SUBJECT: Forwards addl info re second 10-yr inservice insp summary plan per 840817 request.

Re: Turkey Point Units 3 and 4
Docket Nos. 50-250, 50-251
Inservice Inspection
Second 10-year Summary Program

FIRST & SECOND INTERVAL RELIEF REQUESTS

INSERVICE INSPECTION

DATE: 5-30-84	DRAWN BY: E.L. ANDERSON	APPROVED BY:
SCALE: NONE	REVISED:	
REGENERATIVE HEAT EXCHANGER RADIATION SURVEY AS OF 11/2/82		
RELIEF REQUEST NO. 3		DRAWING NUMBER FIGURE NO. 3

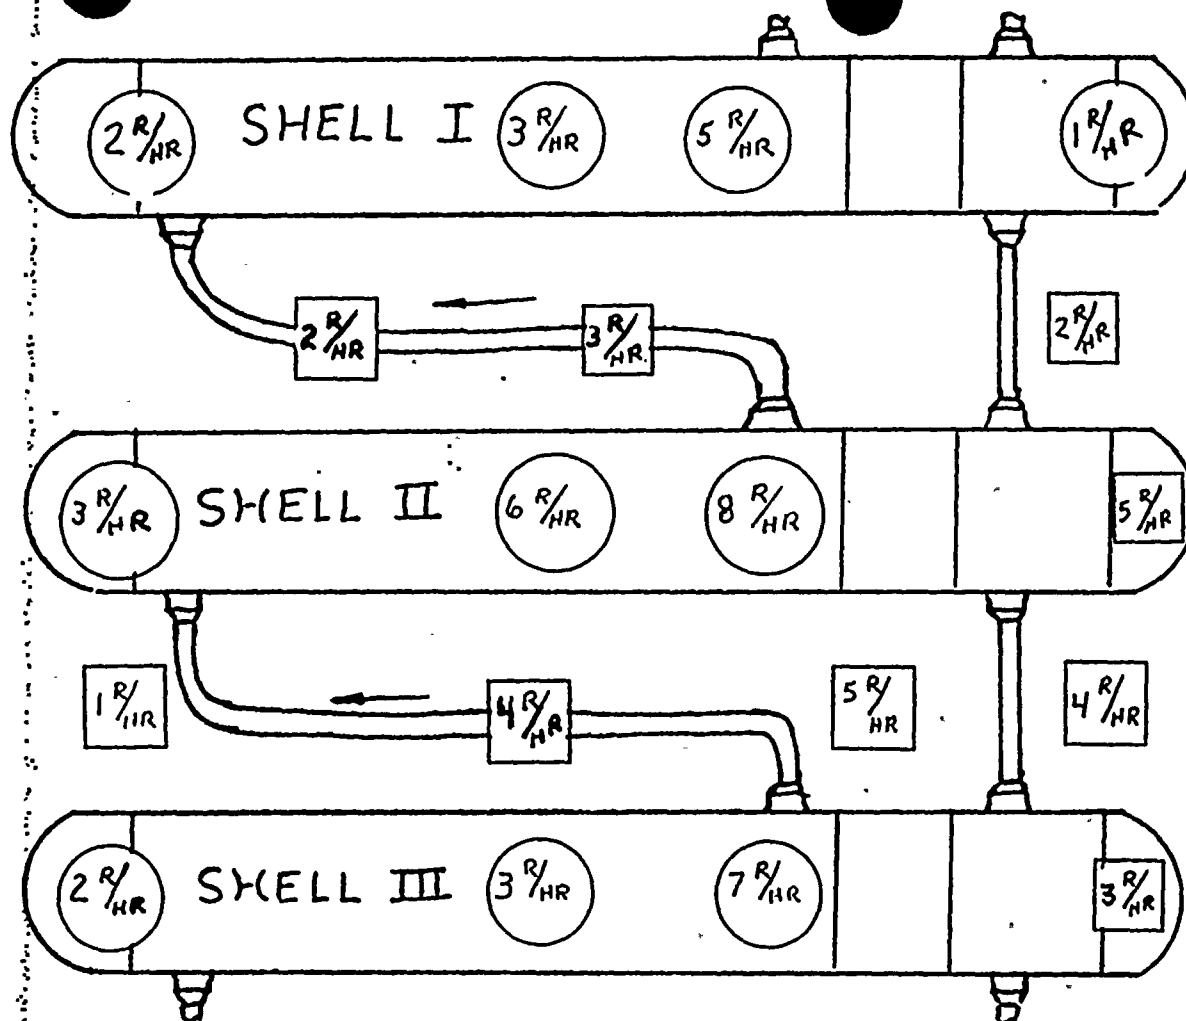
- 1) To perform these examinations, large expenditures of manhours and man-rem are required with essentially no compensating increase in plant safety, coupled by the increase in radiation (see figure nos.3 and 4 for comparison in radiation levels from 11-2-82 to 10-9-83 exposure. Additional areas contributing to the justification are as follows: (surveys were taken on Turkey Point 3, verification was made against Turkey point 4, and determined that the surveys in this relief were identical to unit 4.)

FIGURE NO. 1

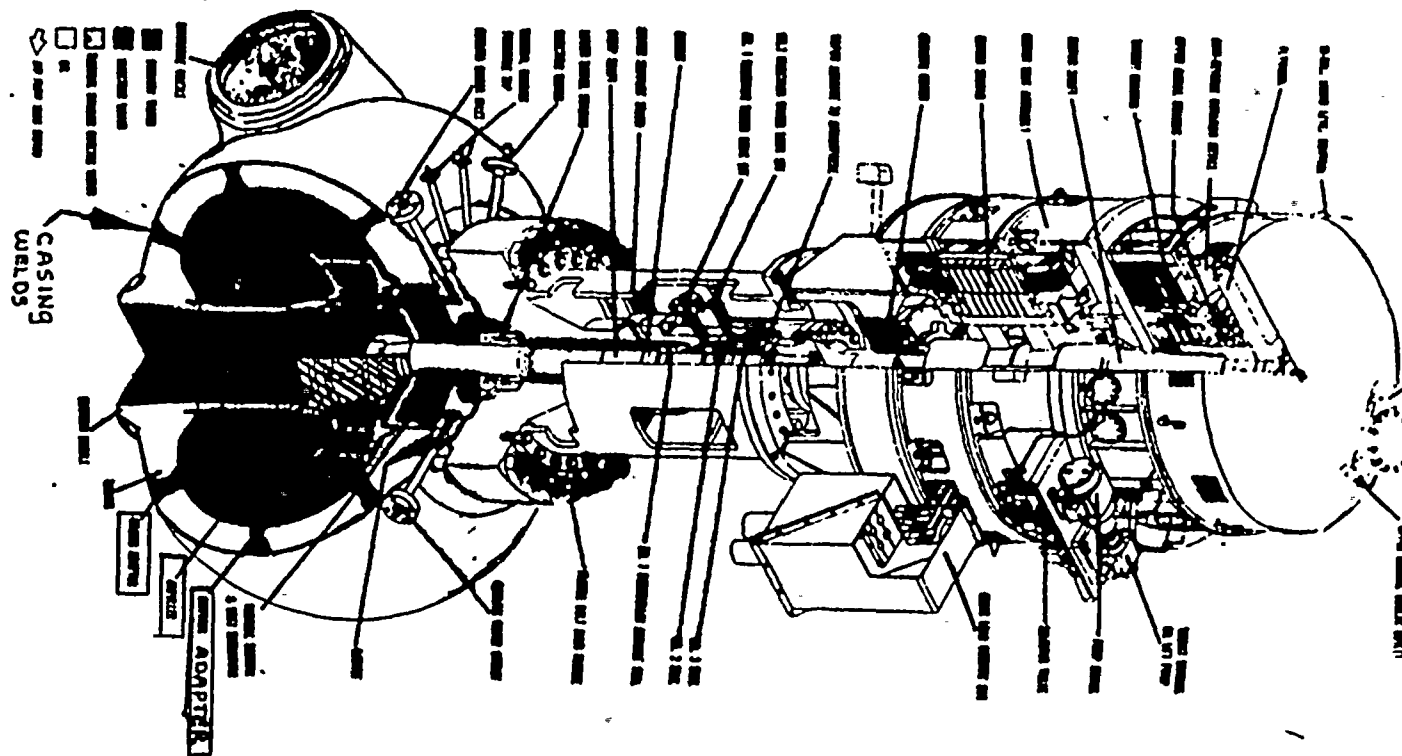
- 2) Radiographic examination is not possible without the complete disassembly of the pump (see figure 1). To perform this examination, large expenditures of manhours and man-rem are required with essentially no compensating increase in plant safety. Based on actual data compiled from the radiographic examination of the Turkey Point Unit No. 3 reactor coolant pump casing welds and visual examination of the internal boundary surface on one pump, in excess of 5900 manhours and 46 man-rem exposure was expended in the disassembly, examinations and reassembly of the pump. These examinations are conducted under somewhat adverse conditions which have far reaching effects as depicted in Figures 2 thru Figure 5.

- 3) There is a very low probability, based upon industry experience, to disassembly pump(s) for maintenance purposes. There is no requirement by the pump manufacture (Westinghouse) to disassemble the pump(s) as part of normal maintenance or inspection. Accordingly, Florida Power & Light Company's procedures do not require disassembly of the pump(s) for maintenance or inspection purposes. There are no reported failures within the pump casings with these model pump(s). It's note worthy to mention that removal of the pump impeller does not provide access to the casing internal surfaces which would still prohibit the inspection (visual and volumetric) of the pump to code requirements. See Figure 1 for items to be removed for code ISI examination compliance.

- 1) Manufacture's shop radiographs, ASME Section III
- 2) Hydrostatic Tests, ASME Section XI
- 3) 100% visual examination of the external surfaces only of one pump casing welds to the extent and frequency of examination category B-L-1
- 4) The alternate examination and tests provide assurance of an acceptable level of quality and safety.

FIGURE NO. CIS-V-13 - REACTOR COOLANT PUMP MAIN FLANGE STUD & NUTS AND PUMP SUPPORTS

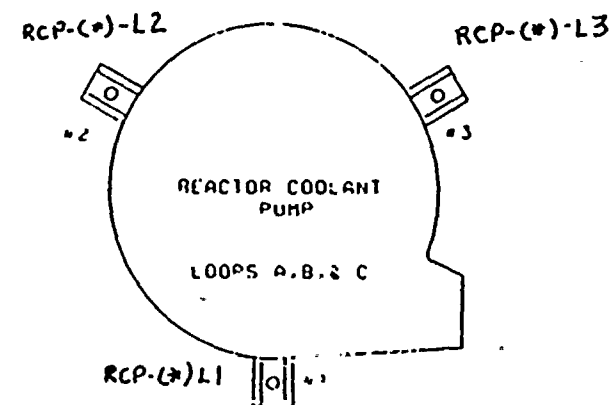
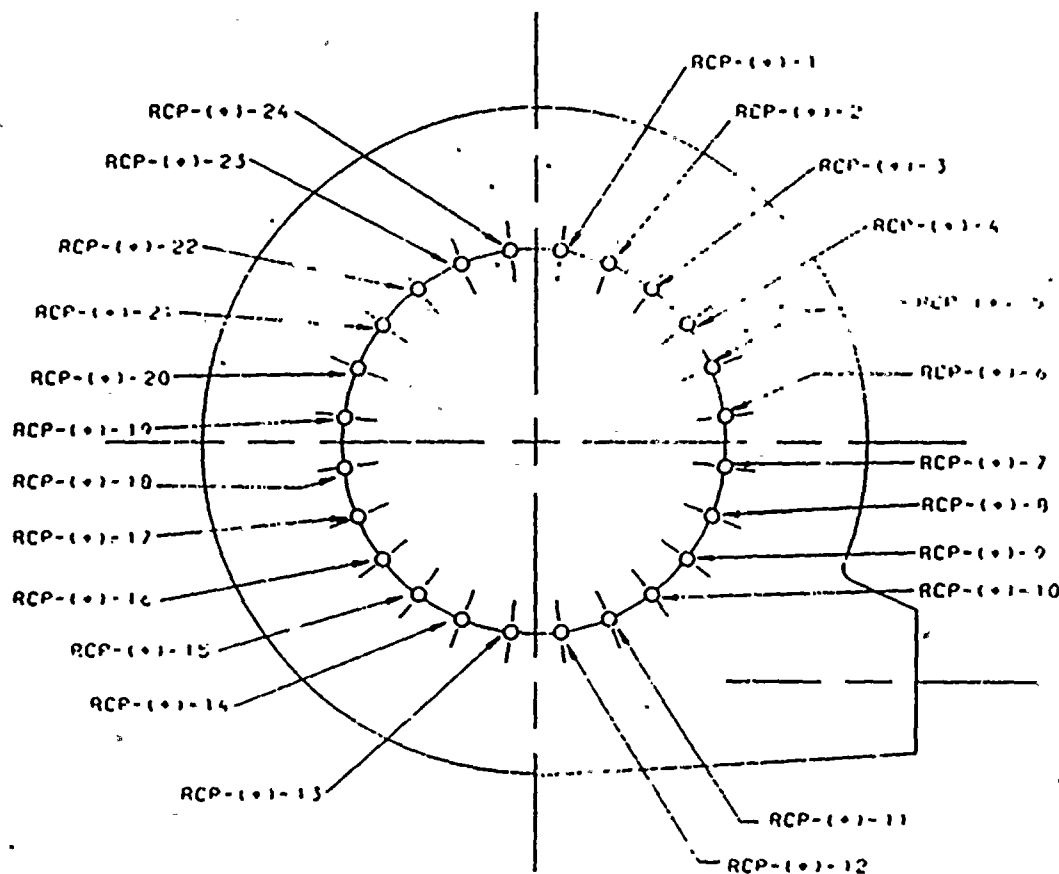
Configuration of the integrally welded supports as welded to the pump body and structural interfaces prohibit meaningful nor conclusive ultrasonic or radiographic code examination. Further 100% surface examination coverage is not achievable due to the inaccessibility of portions of the weld.. Figure no. 1 provides a graphic view of what areas of the lug cannot be examined.

TURKEY POINT UNIT NO. 4		
DATE: 5-30-84	DRAWN BY: E.I. ANDERSON	APPROVED BY:
SCALE: NONE	REVISION:	
REACTOR COOLANT SYSTEM WELD 12" RC-3		
RELIEF REQUEST NO. 10	FIGURE NO. 1

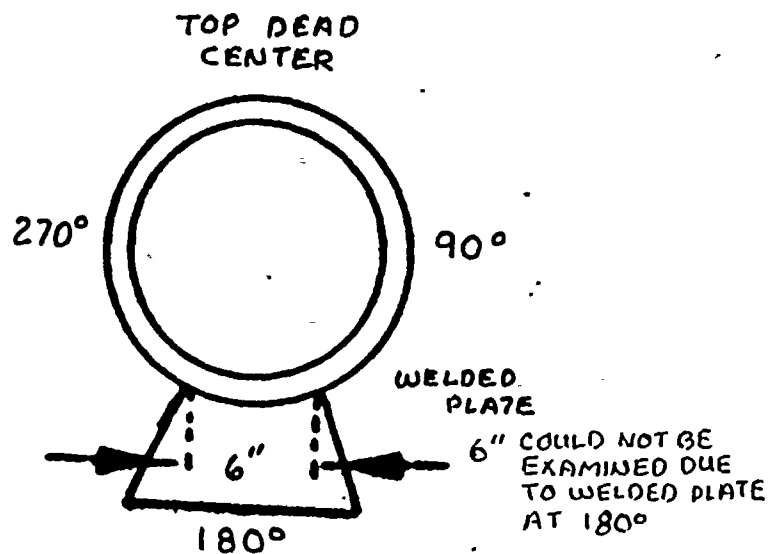
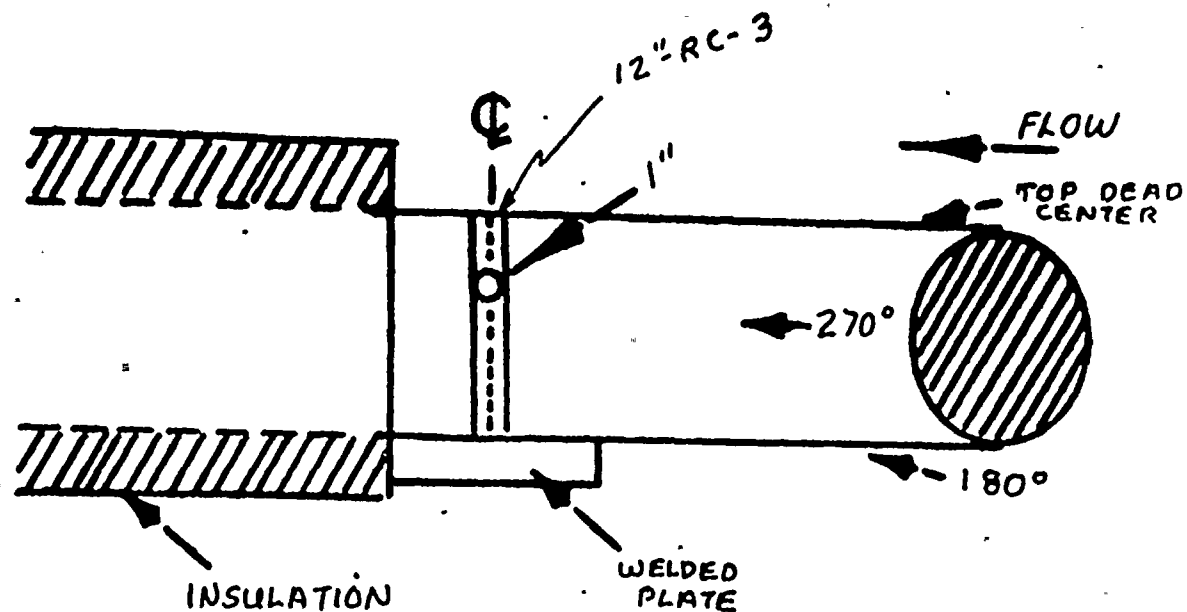
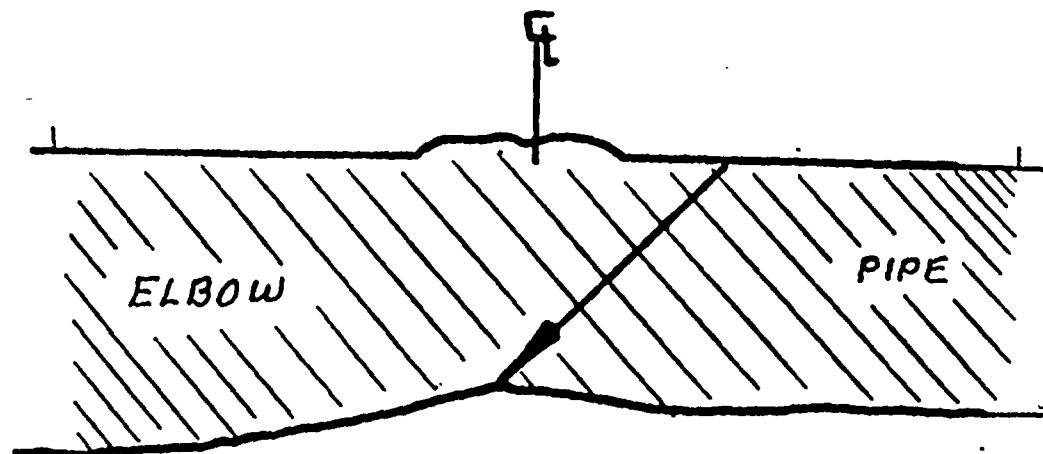
FIGURE NO. 1 12" REACTOR COOLANT LINE LIMITATION
FIGURE NO. 2 14" AUXILIARY COOLANT LINE LIMITATION
FIGURE NO. 3 10" REACTOR COOLANT BRANCH CONNECTION
LIMITATION.

FIGURE NO. 1

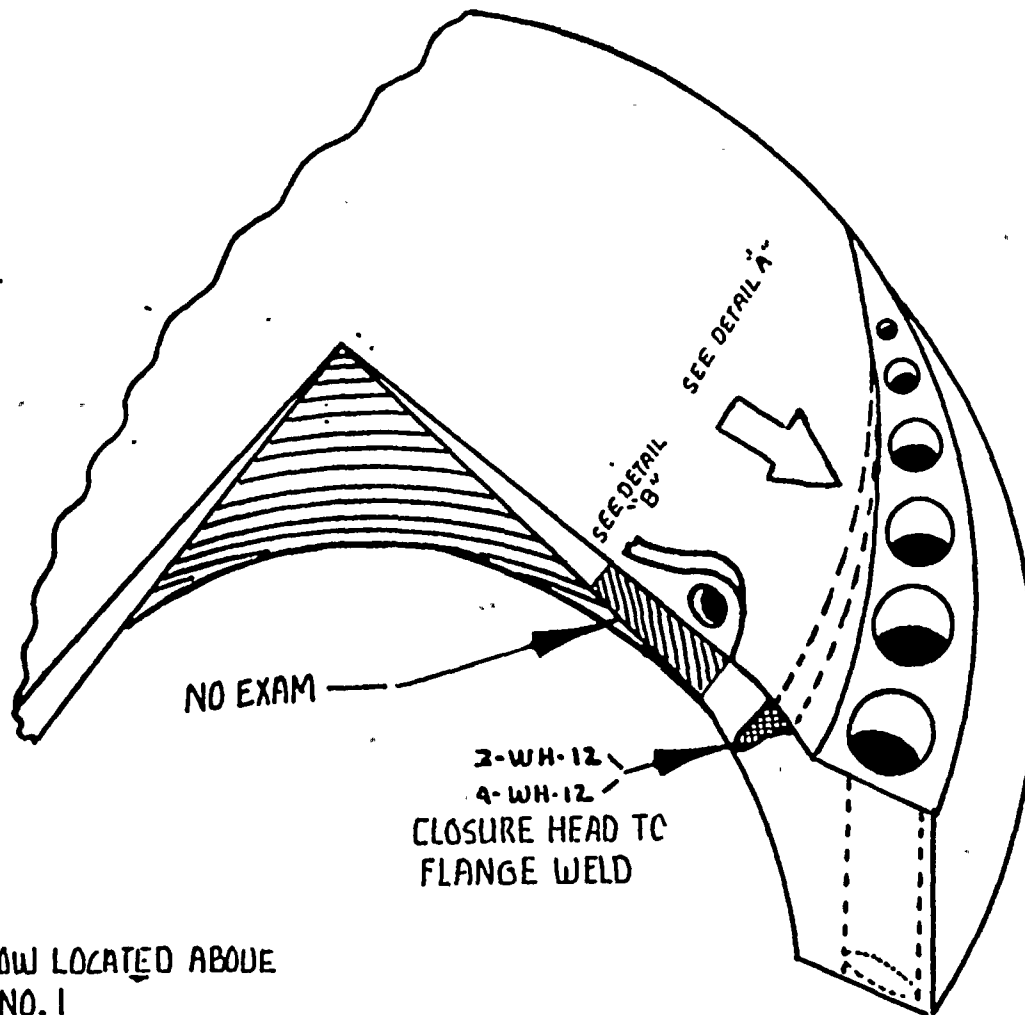
- FIGURE NO. 1. Limitations due to welded arrow located above stud hole No. 1. The arrow limits 7" of circumferential scanning of the closure head weld.

- 1) Periodic System Leakage tests per category B-P, table IWB-2500-1;
- 2) Inservice Hydrostatic test per category B-P, table IWB-2500-1;

RELIEF REQUEST NO. 12	DRAWING NUMBER FIGURE NO. 2
-----------------------	--------------------------------

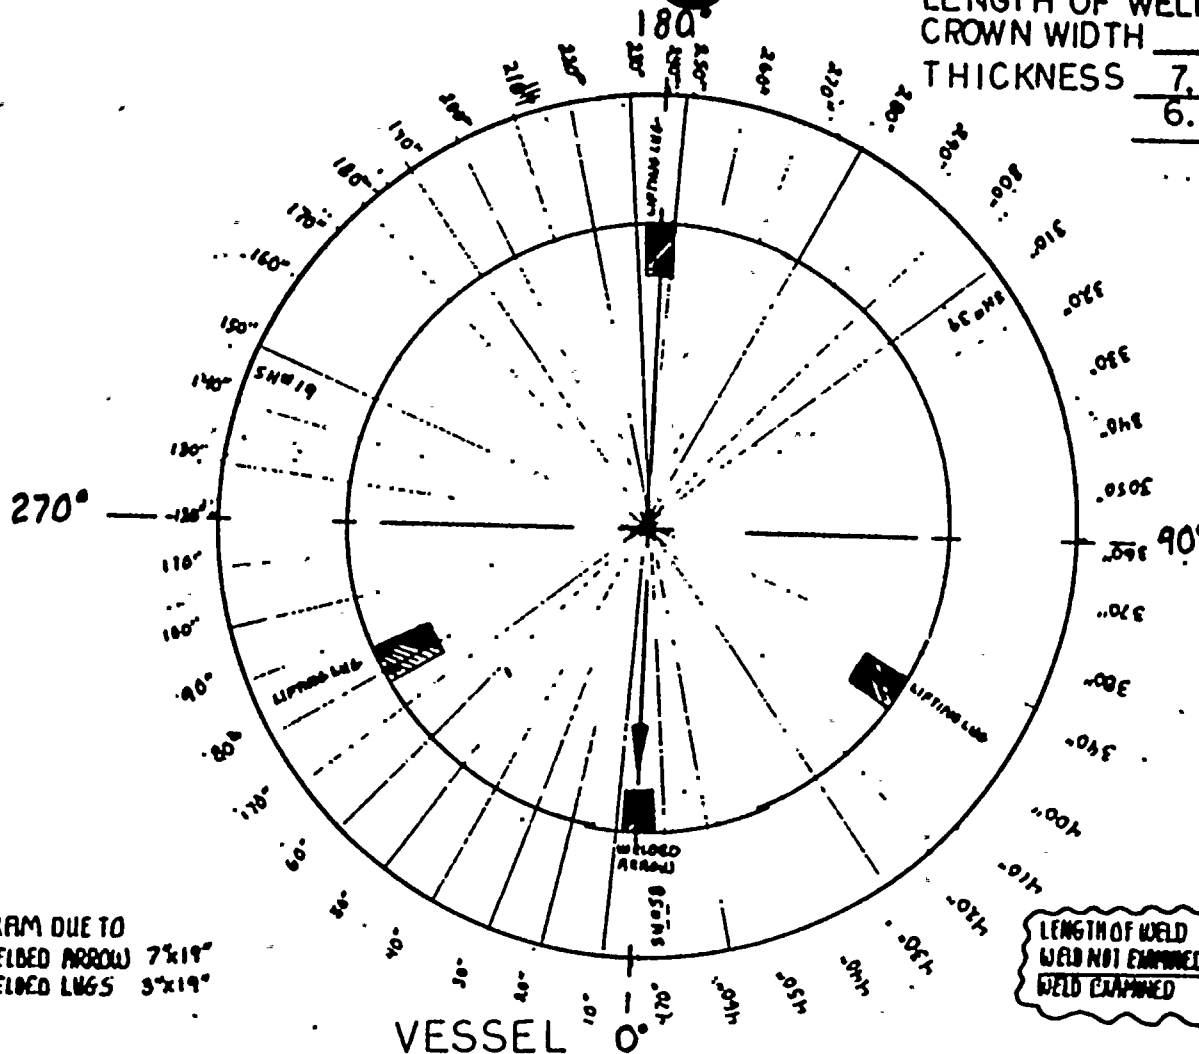
- FIGURE NO. 2 Limitations due to 3 welded lugs located 120 degrees apart, between stud holes 10/11, 29/30 and 48/49. Each lug limits 3" of circumferential scanning of the closure head.
Therefore, the combined length (limitation) due to the arrow (7") plus the lugs (3"x3") totals 16" of weld not examined.

NO EXAM DUE TO
 1. WELDED ARROW 7"x19"
 2. WELDED LUGS 5"x19"
